**RELICENSING STUDY 3.3.8**

**COMPUTATIONAL FLUID  
DYNAMICS MODELING IN THE  
VICINITY OF THE FISHWAY  
ENTRANCES AND POWERHOUSE  
FOREBAYS**

**ADDENDUM**

**Northfield Mountain Pumped Storage Project (No. 2485)  
and Turners Falls Hydroelectric Project (No. 1889)**

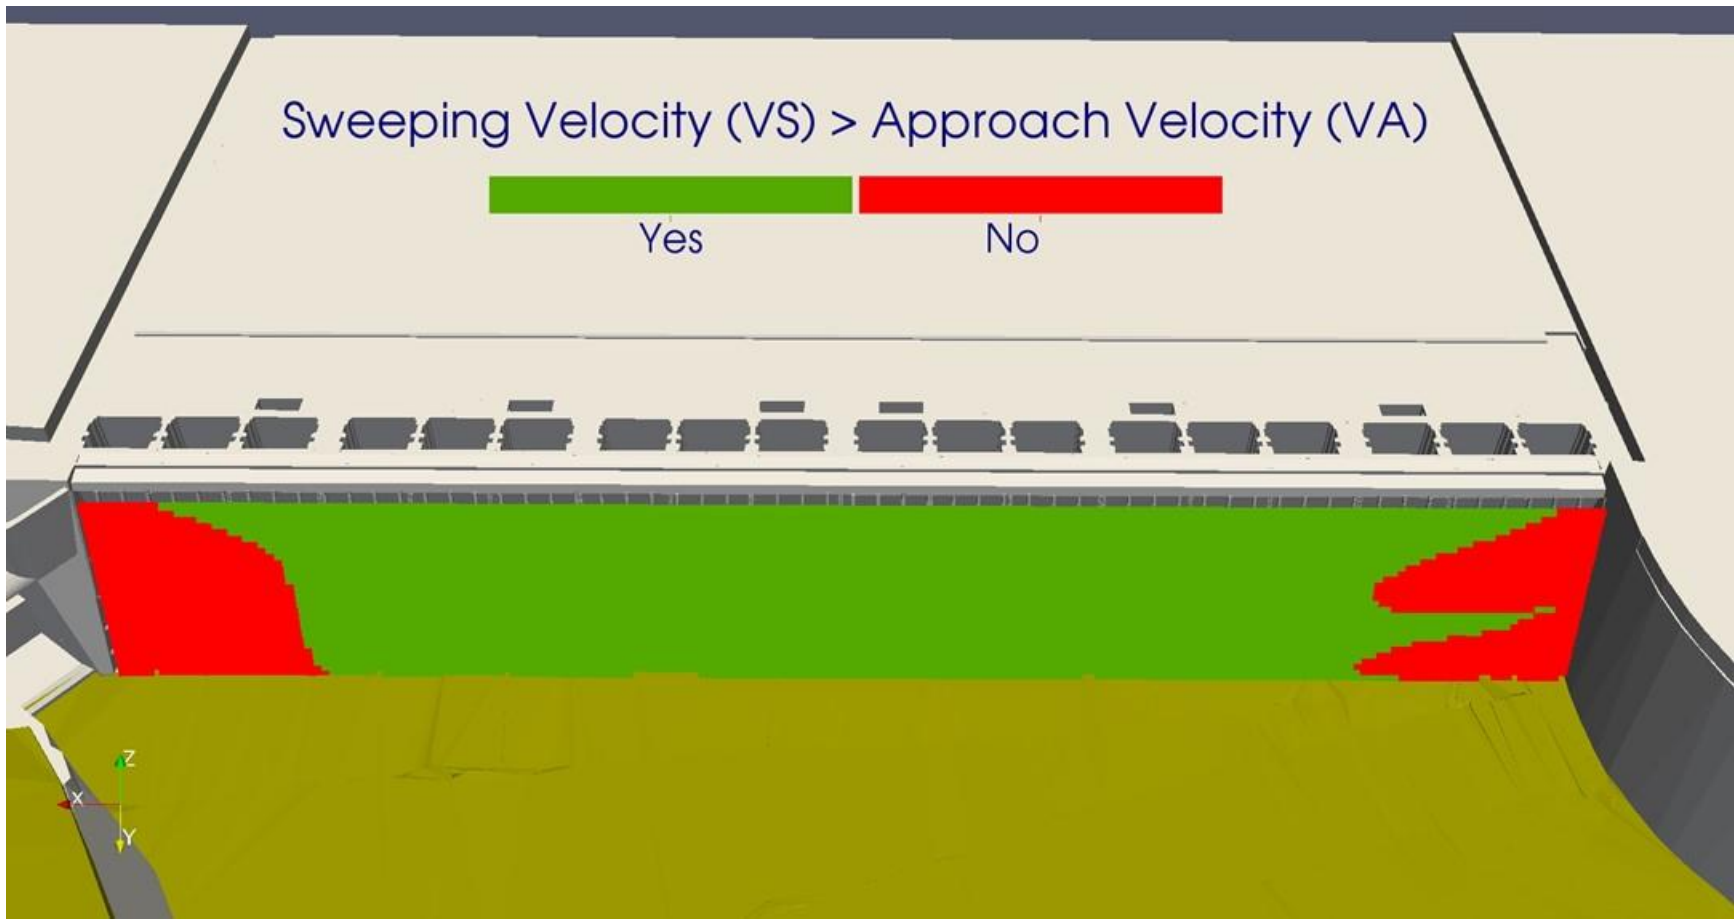
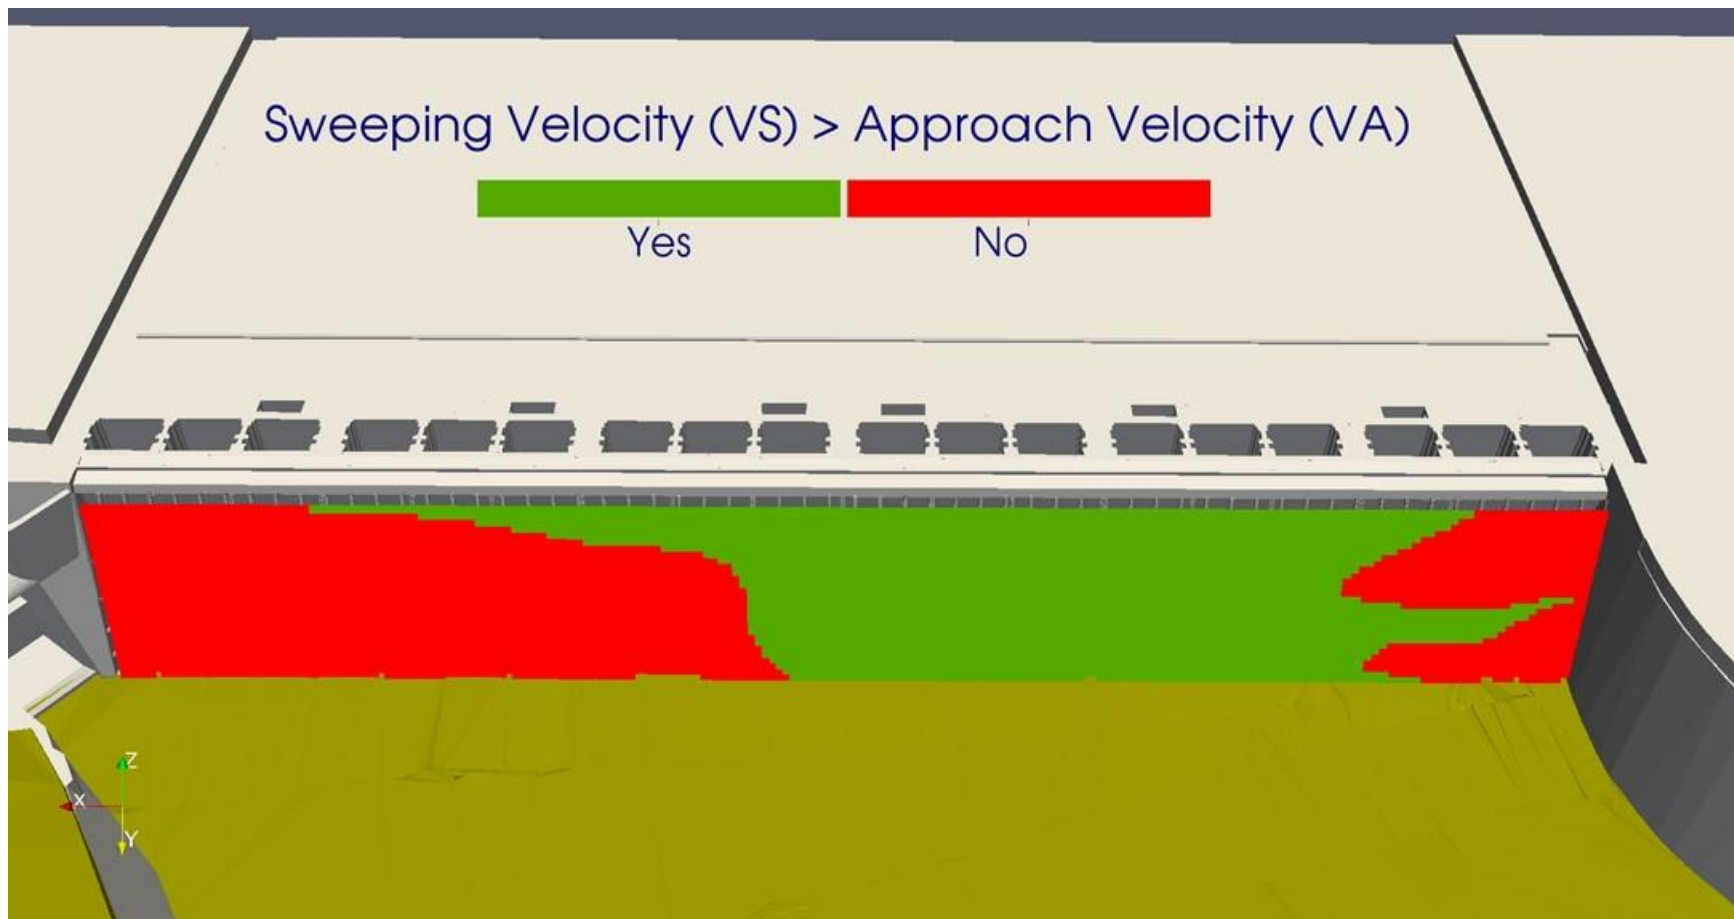
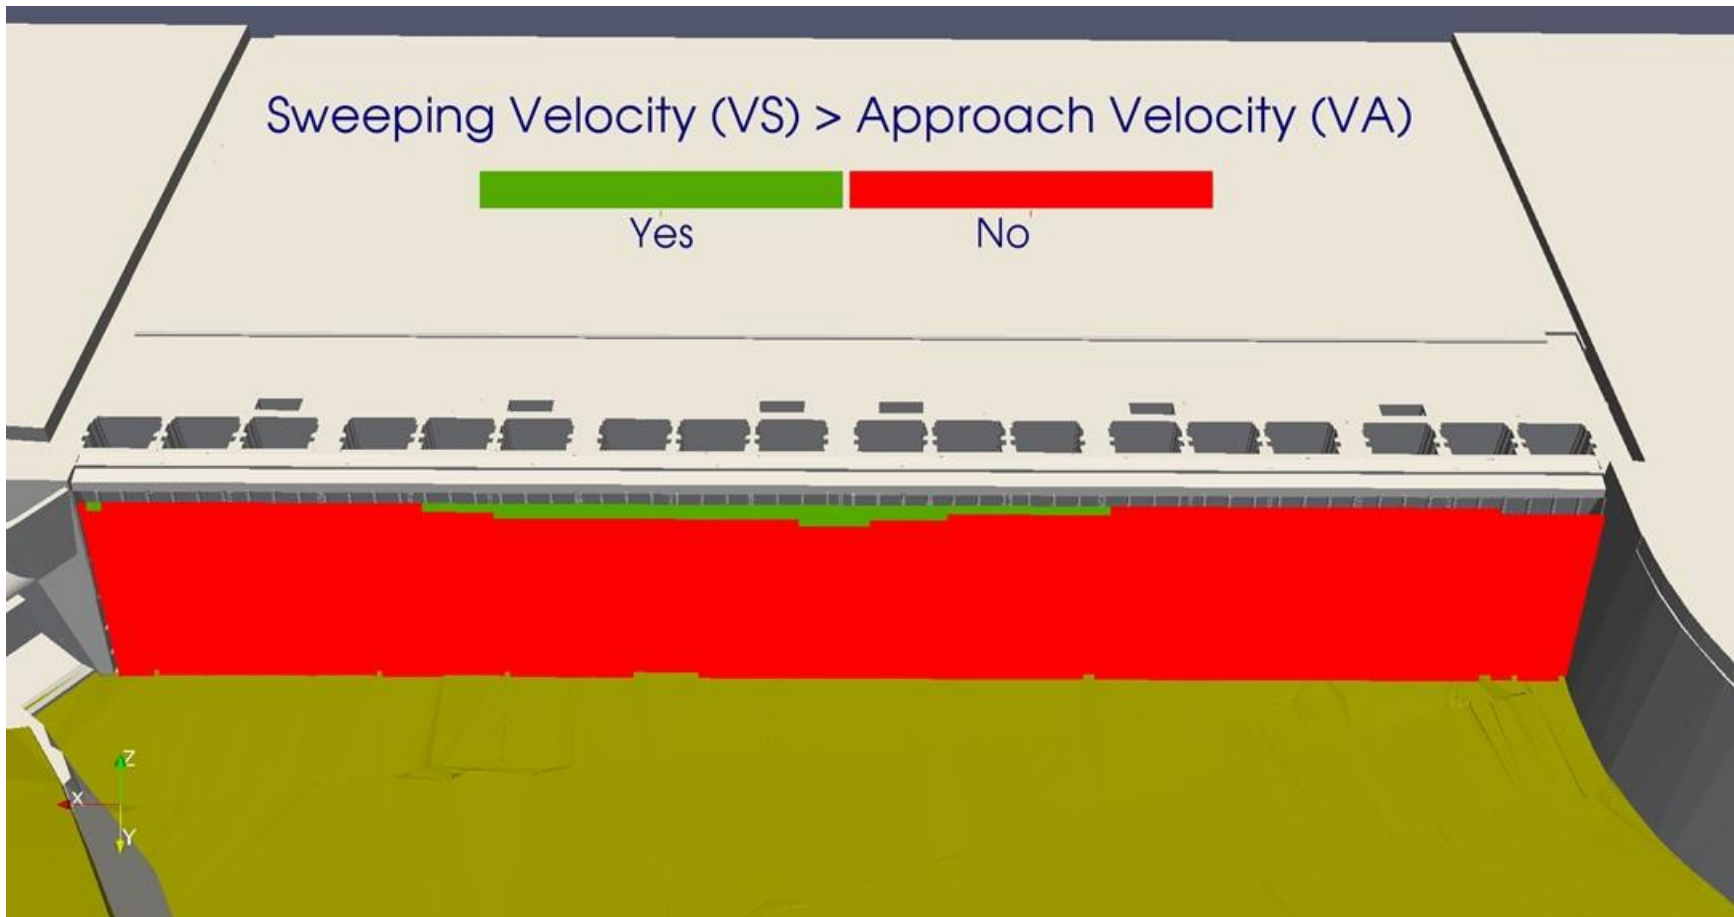
Comment: For Figures 8.3.1-3 to 8.3.1-6; Figures 8.3.2-3 to 8.3.2-6; and Figures 8.3.3-3 to 8.3.3-6: Include additional intake rack figures to display component velocity. For figures showing approach velocity, the scale should have a maximum of 2 fps such that all approach velocities exceeding 2 fps are red. For figures showing the sweeping velocity, the color scale should be binary such that  $VS > VA$  is green and  $VS \leq VA$  is red. The sweeping velocity figures should show directionality.

Additional plots showing the component velocity (VS and VA) comparison in front of the intake racks with a binary color scheme such that  $VS > VA$  is green and  $VS \leq VA$  is red were generated for Scenarios 3-1, 3-2 and 3-3. [Figure 2.15-1](#) shows the component velocity comparison for Scenario 3-1, [Figure 2.15-2](#) shows the component velocity comparison for Scenario 3-2, and [Figure 2.15-3](#) shows the component velocity comparison for Scenario 3-3.

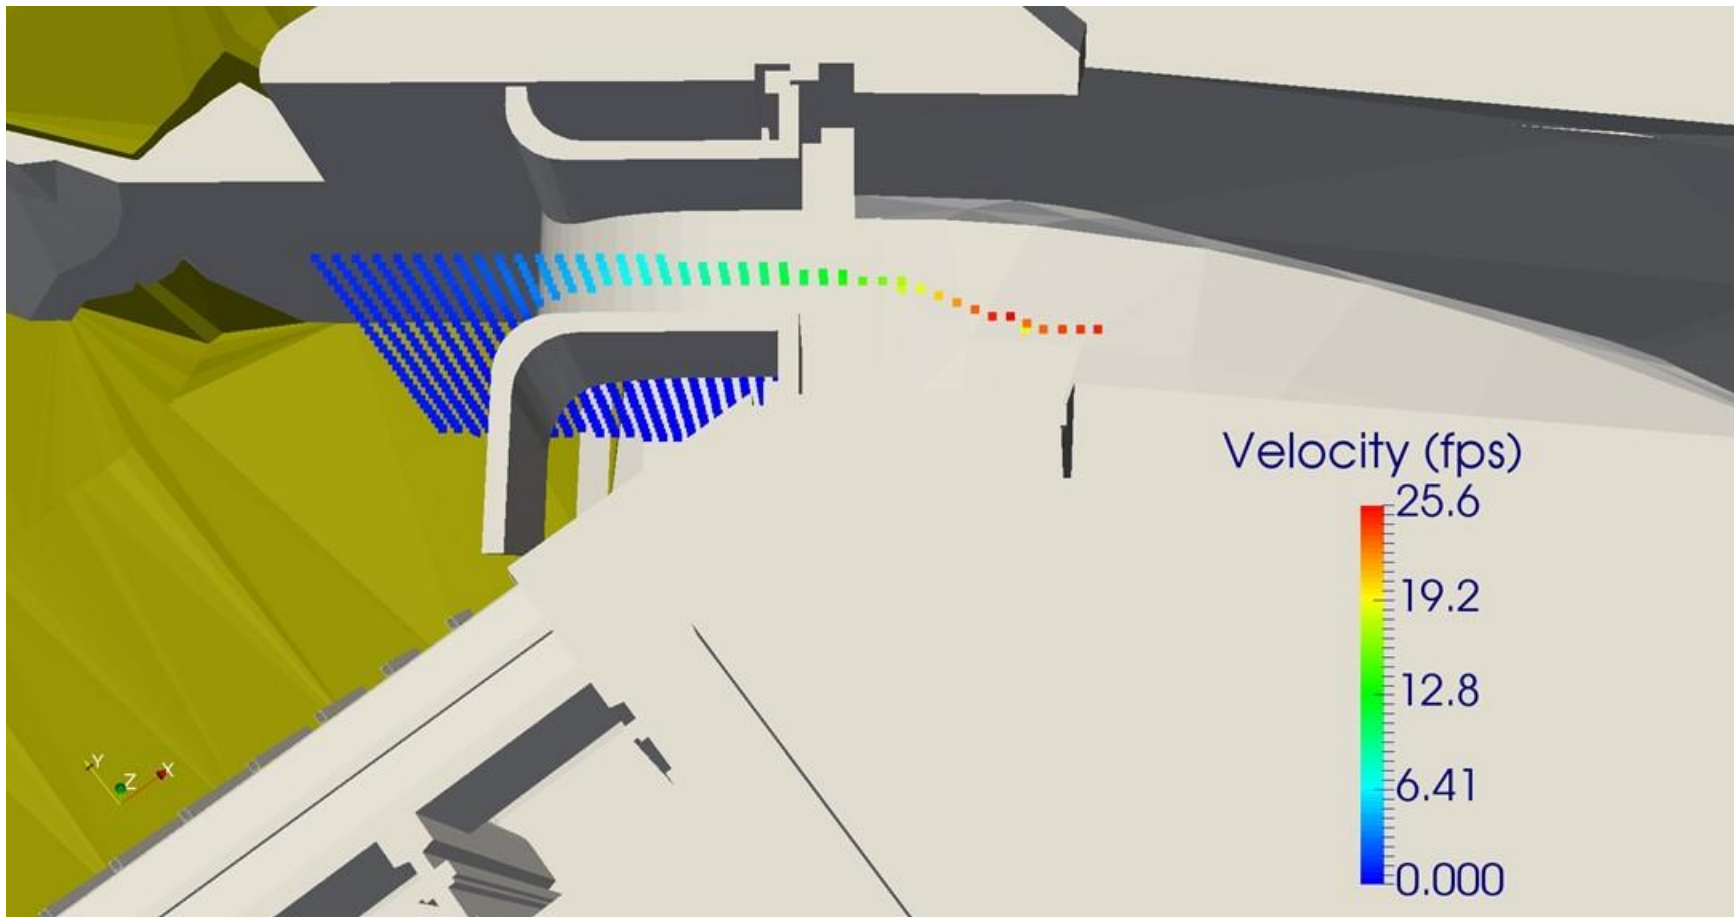
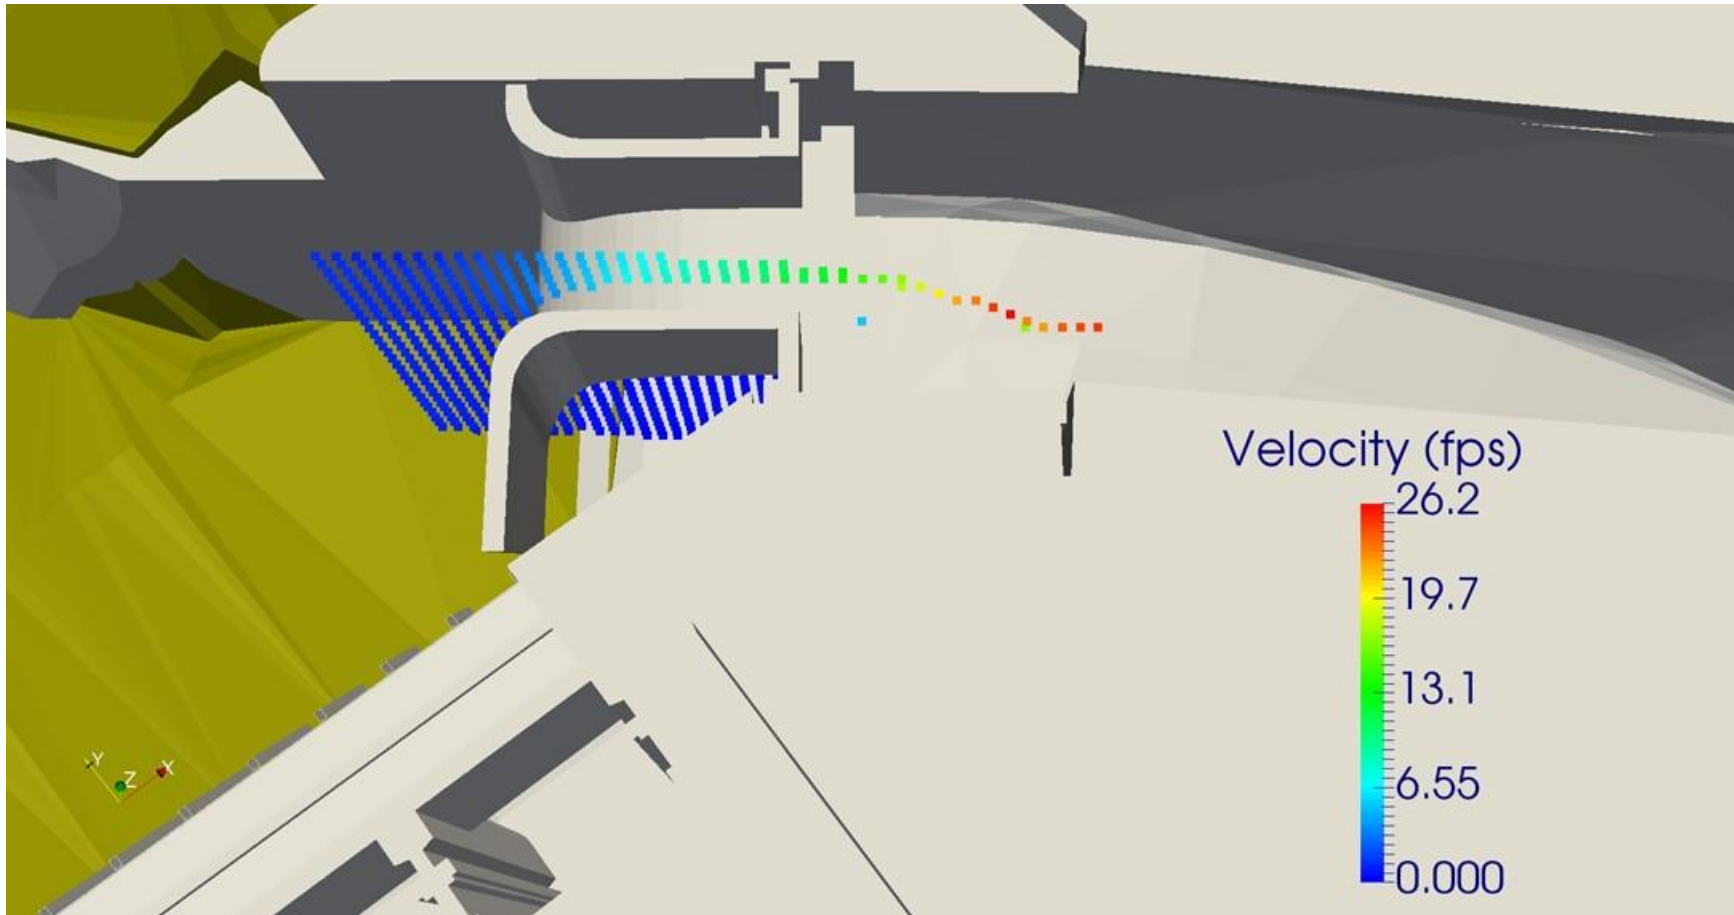
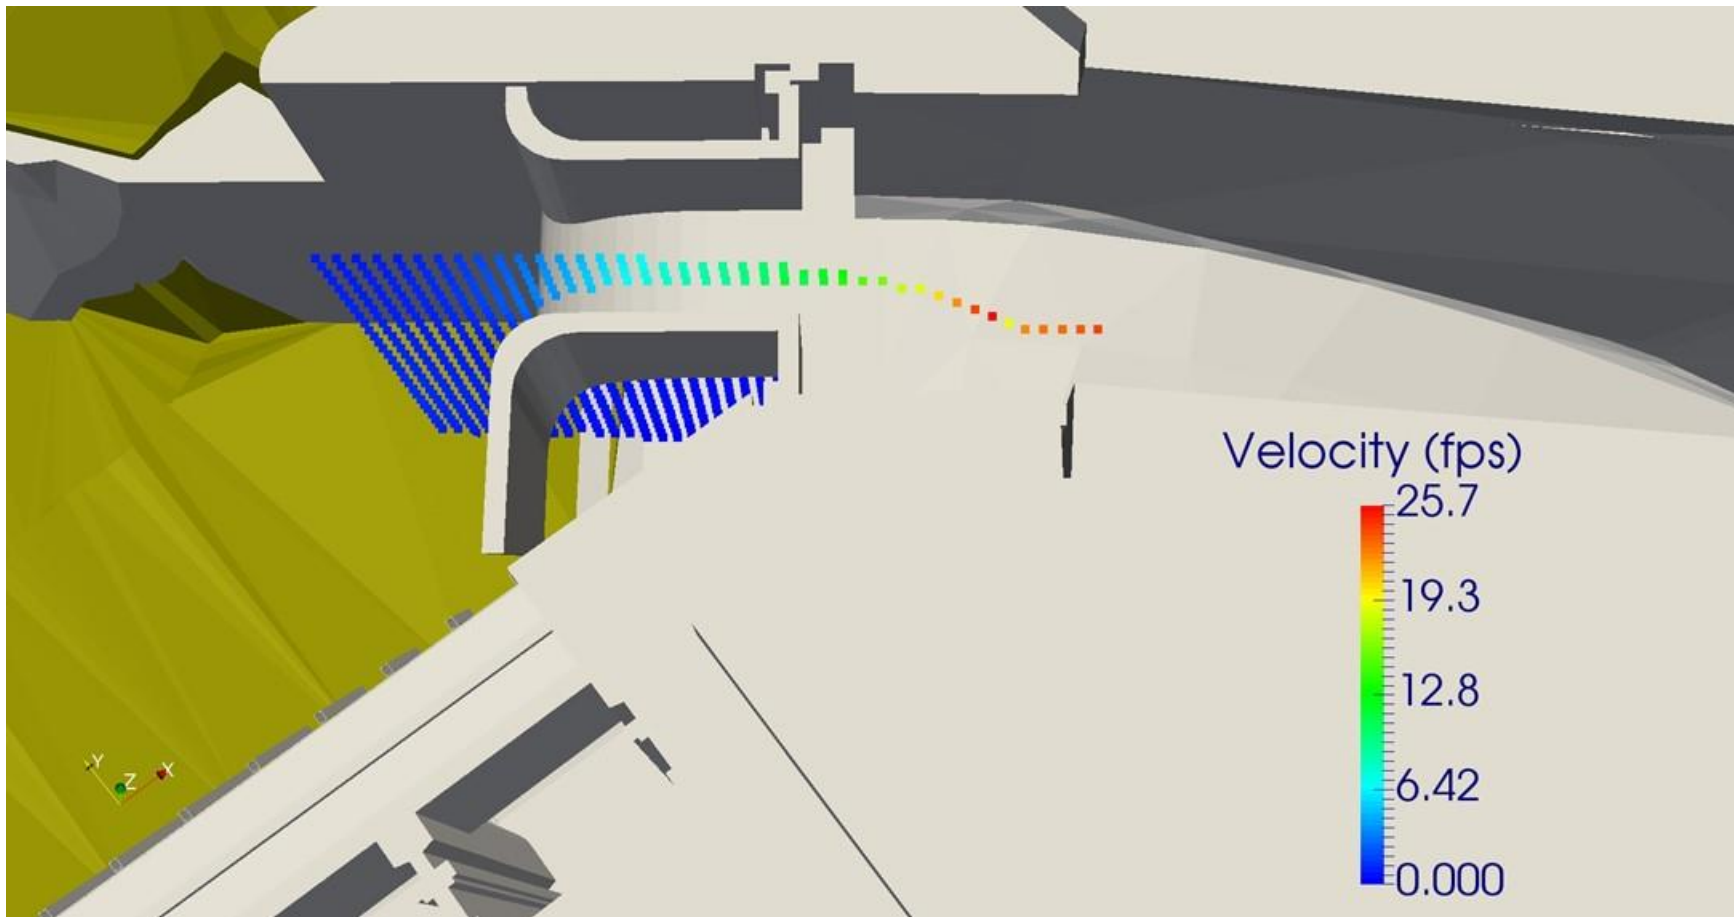
Comment: For Figure 8.3.1-6; Figure 8.3.2-6; and Figure 8.3.3-6: Include profile views from the forebay across the fish weir to the boundary condition of the model showing acceleration and velocity.

[Figure 2.16-1](#) shows a velocity profile across the fish weir for Scenario 3-1, [Figure 2.16-2](#) shows a velocity profile across the fish weir for Scenario 3-1, and [Figure 2.16-3](#) shows a velocity profile across the fish weir

for Scenario 3-3. The velocity profiles extend across the fish weir and extend downstream to the downstream end of the 0.5 foot mesh block (mesh block 3). The profiles do not extend to the downstream boundary because the model was not developed to model flows below the fish weir. Below the 0.5 foot mesh block the water is shallow compared to the mesh cell size such that the fluid fraction is less than 0.5 in many of the cells making it inappropriate to extract results in this area. The fish weir serves as the control section for the water leaving the forebay.
